SPARS NEW YORK REGIONAL MEETING

REVIEW : "PROBLEMS AND SOLUTIONS / AMPEX 1200"
SPEAKER: MICHAEL GUTHRIE, DIRECTOR OF ENGINEERING
RECORD PLANT STUDIOS, LTD. -NYC

Record Plant Studios MM-1200 modification procedures:

CHANGES AND ADDITIONS TO TAKEUP TENSION CONTROLLER KIT * Record Plant Studios
2/16/81

13) MDA mods.

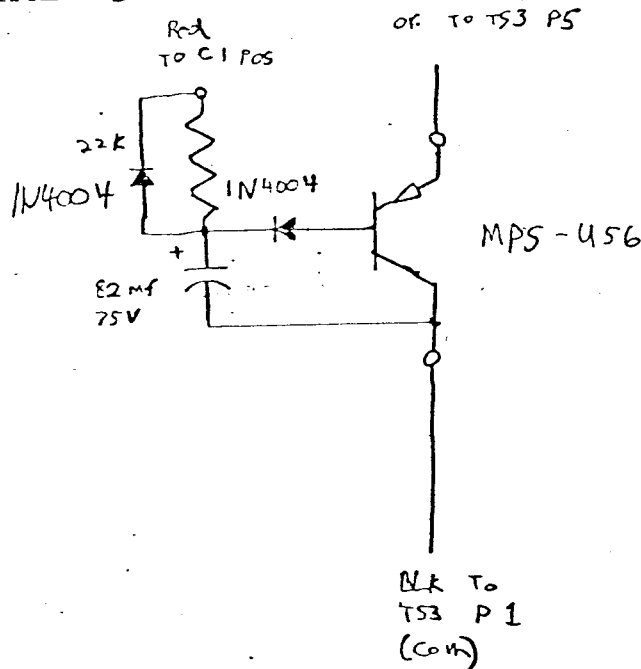
- 1) install SFT 31307 transistors in Q101,102,105,106. Add the 220 ohm resistors, and the diodes as shown in the tension kit instructions. Note the 013-678 can be replaced with a 1n4004 etc. if you're not an Ampex dealer.

- 2) add two fuse holders to the PWA panel as shown. cut the lands leading to the Q1,7 collectors between C2,9 and the transistors. Drill two holes to pick up these lands on each side and wire to the fuse holders. install 1/4 or 3/8 A sol blow fuses in the fuse holders. These fuses will, at least in most cases, protect Q1,7 from failure when the transistors on the heatsink assembly fail.

- 4) Make two duct plates as shown in the drawing. these should be black anodise aluminium if possible or painted flat black if not. Drill and tap four holes for 6-32 screws in each heat sink, and use 6-32 X 1 1/4" screws, lock washers, and flat washers to attach the duct plates to the heat sinks.

- 5) Remove the fan, and turn it around when reinstalling it. it will now blow out. Do not install a filter in this location.

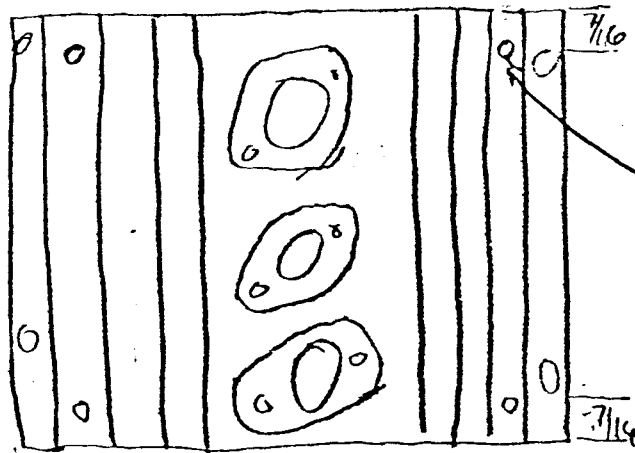
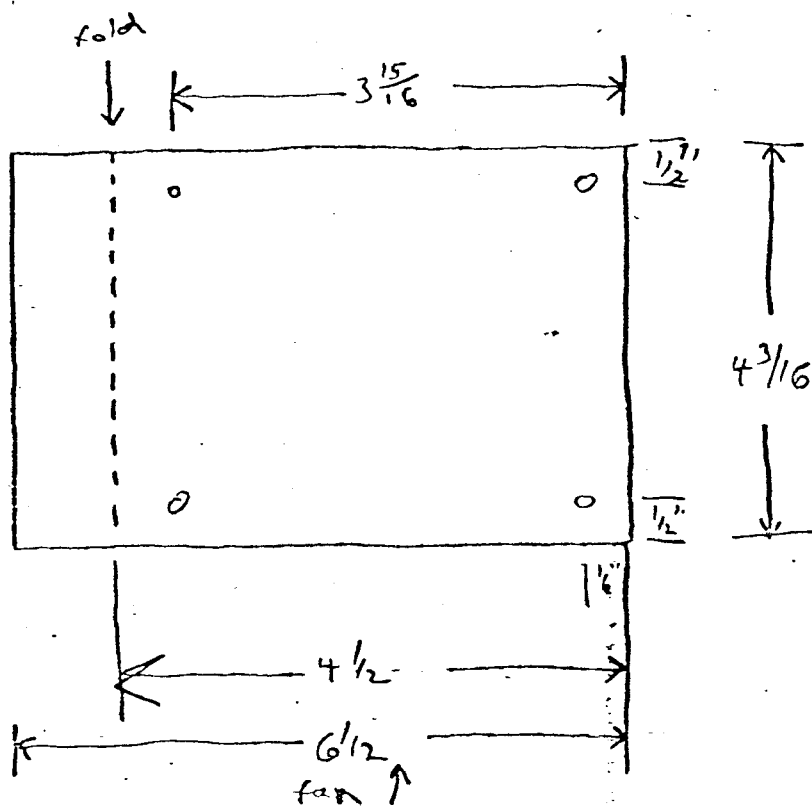
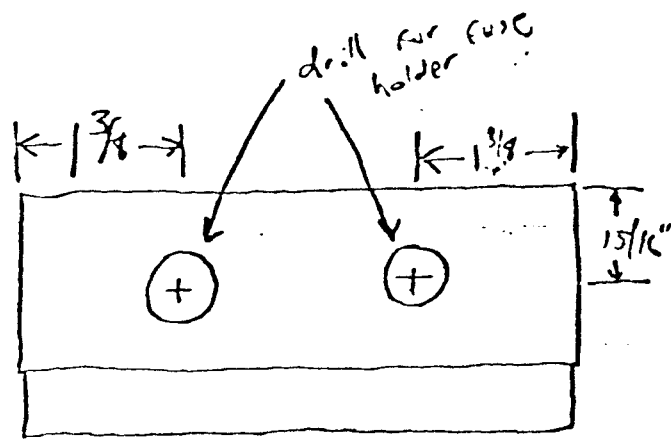
- 10) remove C3 from TS3. near TS3, mount a small turet board with the following on it.

- 11) the MPS-U56 collector connects where C3 neg was. the emitter connects where C3 pos was, and the resistor gets a new wire back to C1 pos.
- 12) solder all ring lugs, both new and existing, and add a lockwasher between the lowest lug and the cap on C1,C2,C4,C5. Neatly tie all new wiring, and reassemble the power supply.
- 13) add an 18 ga wire from Transport Connector J5 (burndy) ^{pin 5} to transport controll chassis J1 pin 15.
- 14) reassemble machine, check audio noise with notape, in play, with the head gate closed. reset tensions and power supply voltages if necessary and check for proper operation of all functions.

drill and
Tap 4 Holes
6-32

MM-1200 flutter indicator mod

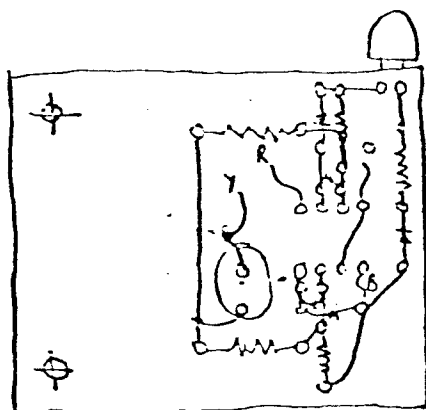
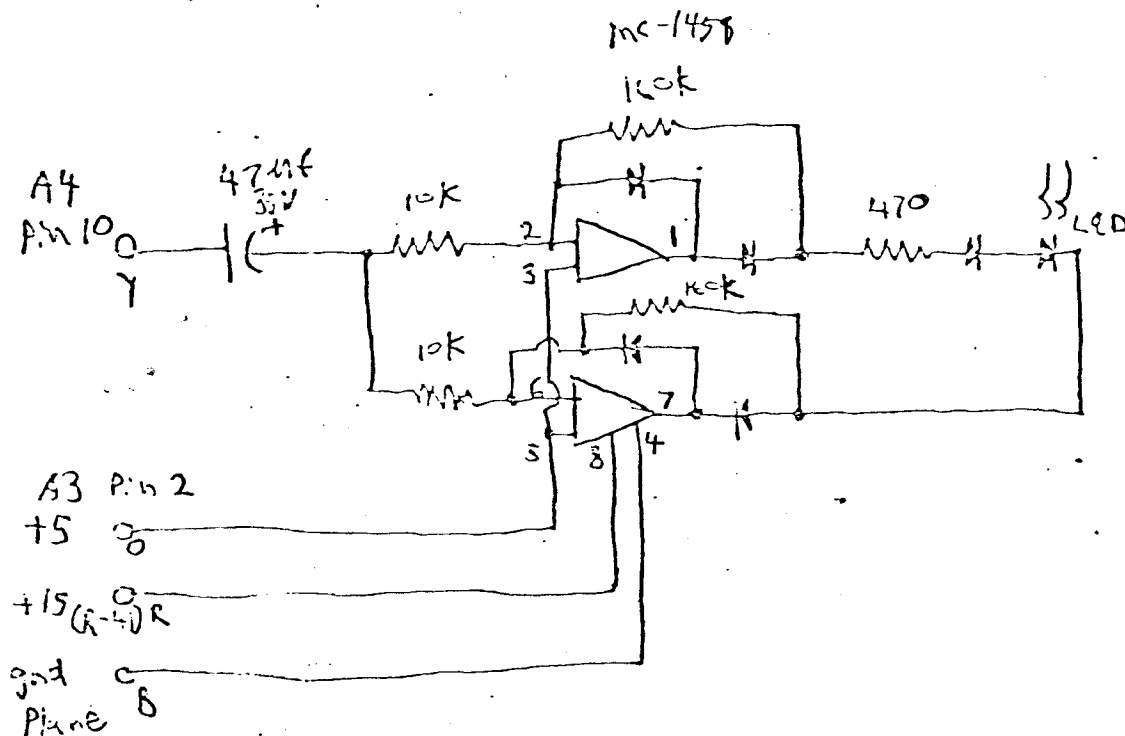
- 14) Here are two unnecessary, but nice additions for the MM-1200. the first is a piggy back board for the capstan servo card, which indicates the presence of bad bearings, servo oscillations, heavy corrections from synchronisers etc which might cause flutter. It is quite sensitive, with a little practice, you can learn to identify flutter below .07%, before it becomes a problem.

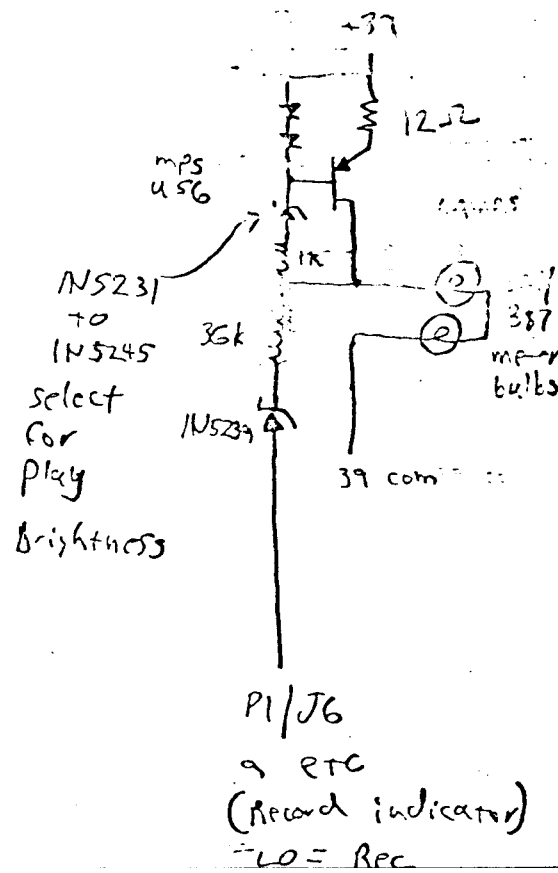
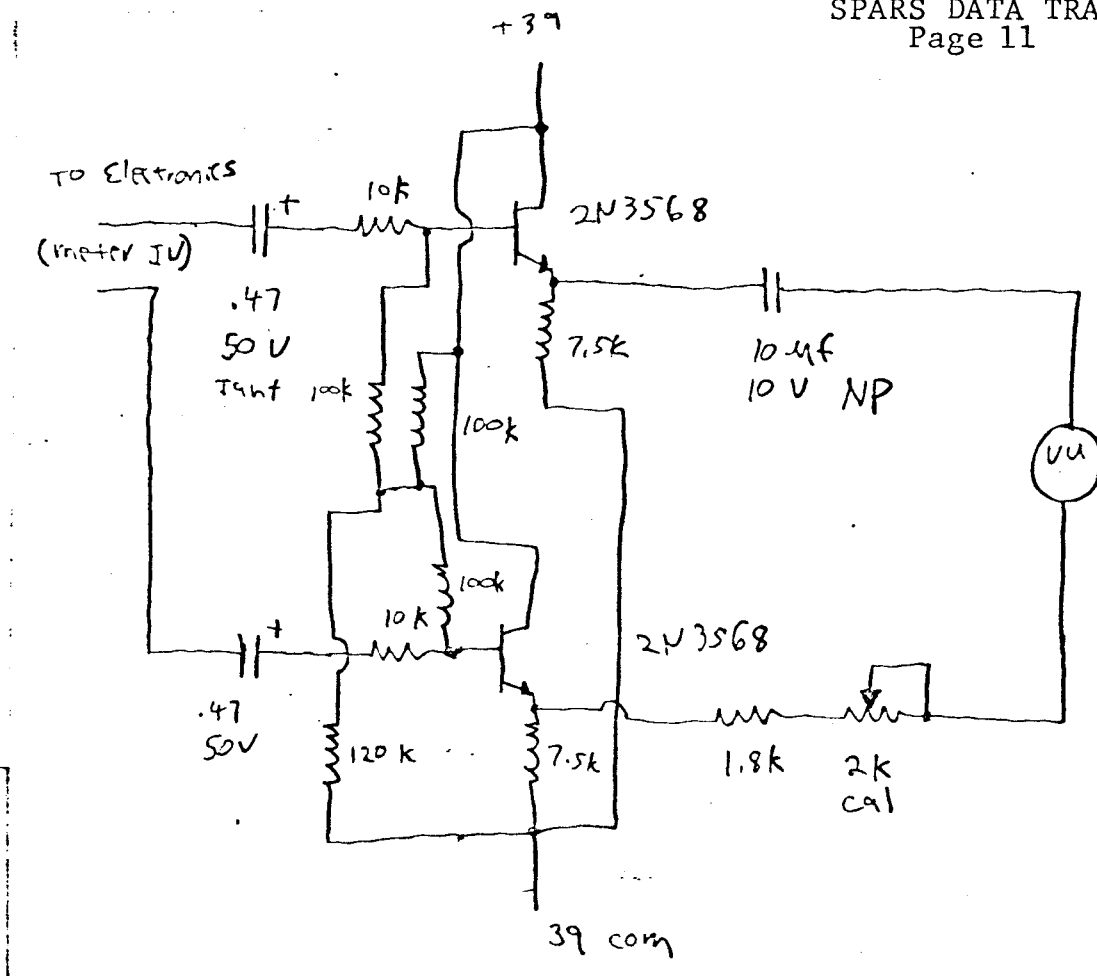
This one is a meter buffer amplifier that will eliminate the distortion caused by the VU meters. This distortion can, under some conditions, be as great as the distortion from the tape. also on this card is a meter lamp buffer that dims the lamps in play, and brightens them in record, giving record indication on the front of the machine. the amplifier does not affect bias metering as an op-amp might, and does not affect the common mode floating of the output transformer.

Page 1A

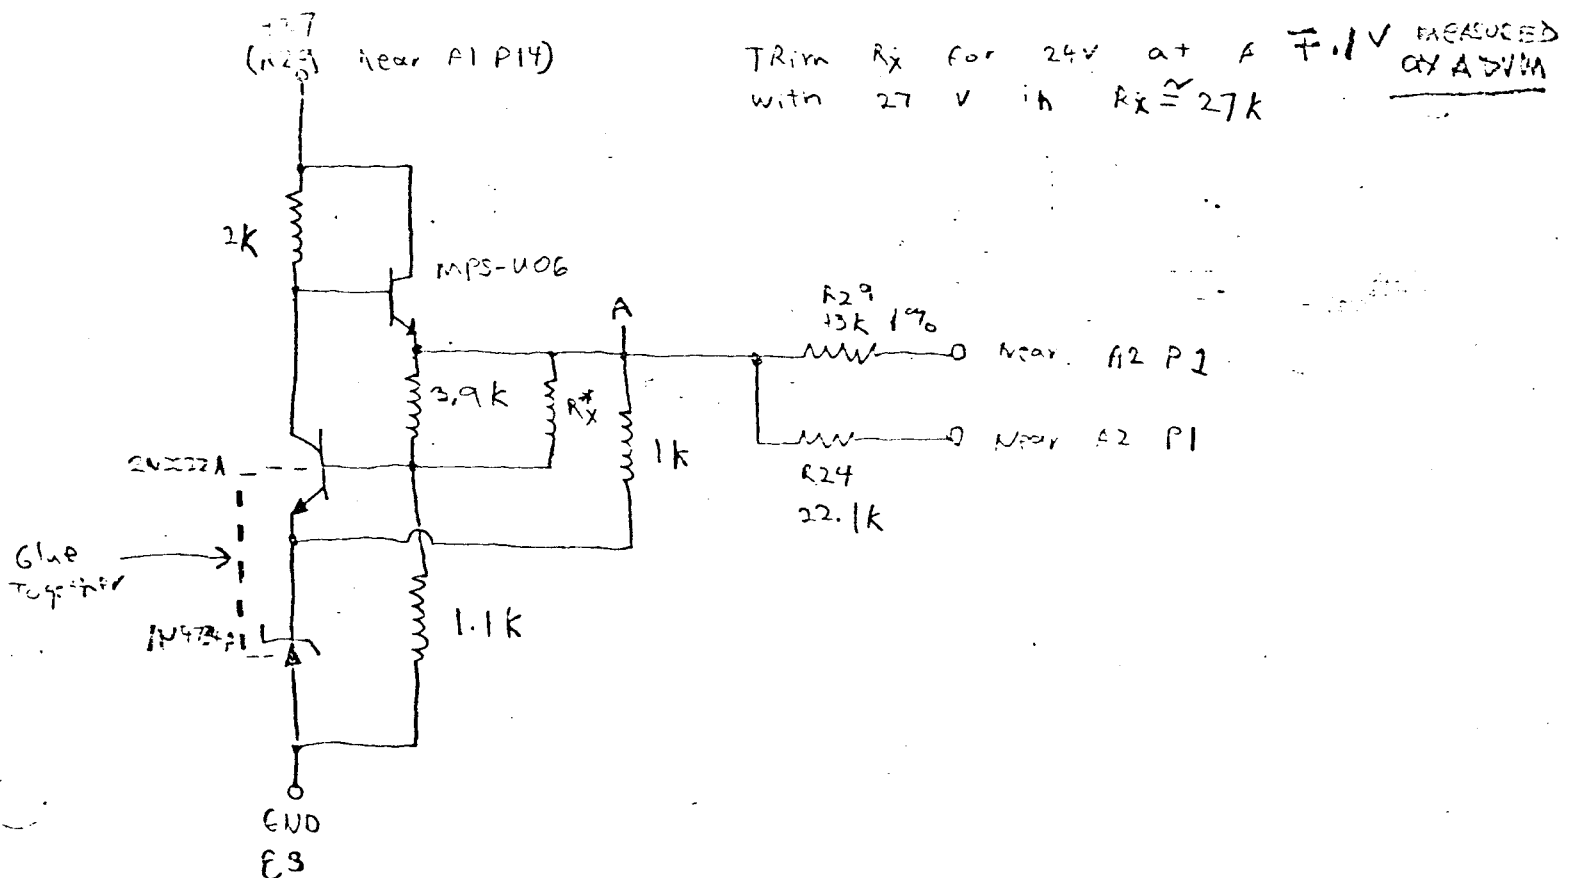
Do not install R 29, but rather install a wire to go to new regulator board. This wire goes in the hole connected to A2 pin 5. (this eyelet is near A2 P1)

Do not install R 24, install a wire here also. the eyelet which connects to A2 P4, near A2 p1

Build the aux 24V regulator shown below, and install on card.

Be sure the MDA has SDT31307 transistors on heatsink, and add the diode to the collectors of Q6 and Q3.

Note changes in takeup MDA, and regulator addition shown below

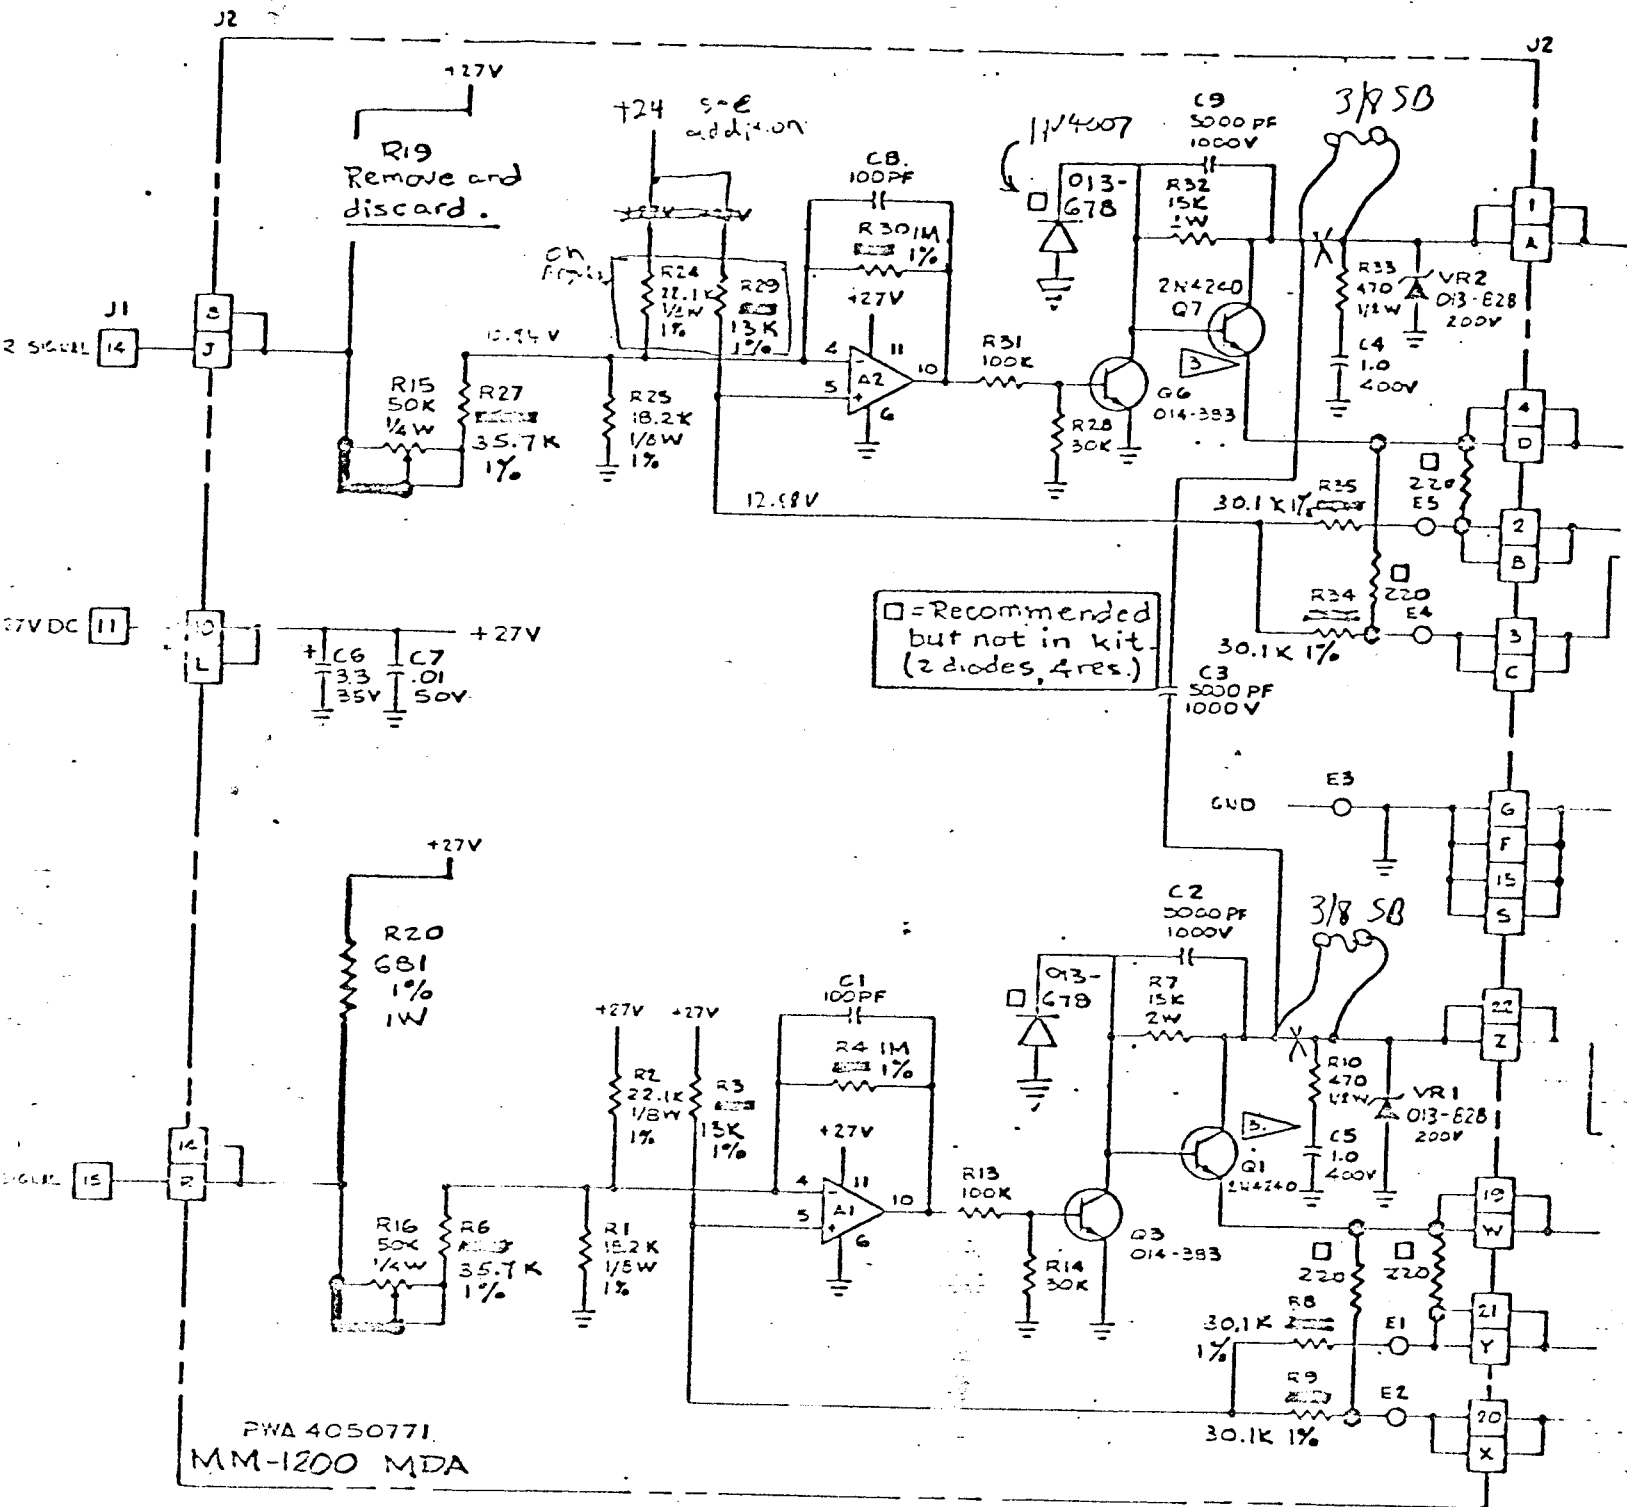
Before completing installation as per page 6, modify the Tension Controller PWA as following; (note changes on schematic, Page 6A)

Add two 1N34 diodes from the bases of Q19, Q20 respectively to the Servo Disable line U10 p13. use tubing on the leads, and place them on the top side of the board

add a 1N5256B zener across c12. the banded end goes to the side connecting to U1 p2. Place this diode on the back side of the board, under C12.
